City of Santa Barbara
Planning Division

Memorandum

SUBJECT: Staff Evaluation of proposed alterations to property listed on the Potential Historic Resources List

ADDRESS: 225 State Street

View of building after 1925 Earthquake.

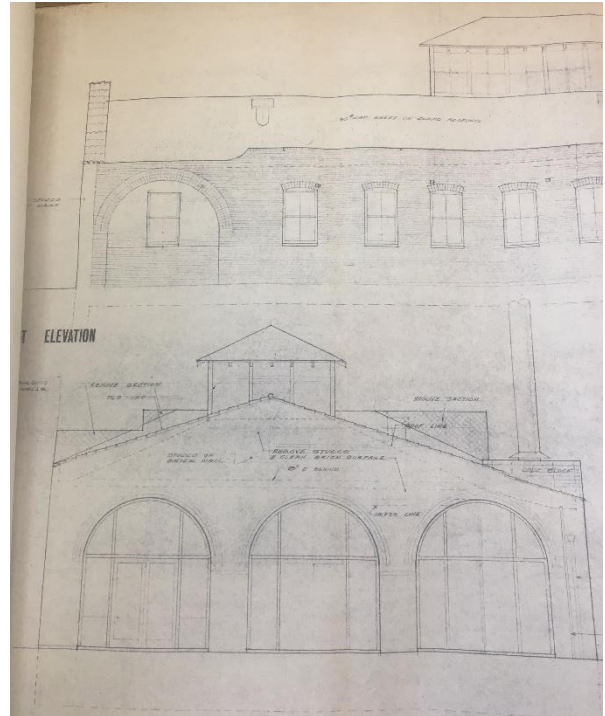
The property will be given a new use, but the proposed alterations will not remove a distinctive or original feature.

The brick façade with large arch openings on State Street and the terra-cotta coping are the distinctive features of the building that will remain.

C. 1970 photograph of the building.

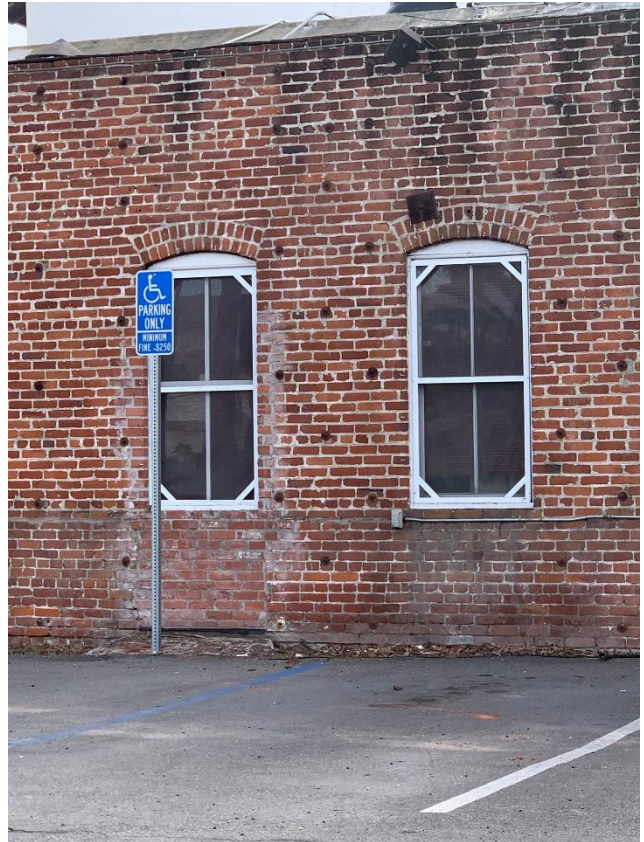
The removal of the stucco in 1977, was a change to the building that acquired historic significance in its own right and will be retained and preserved.
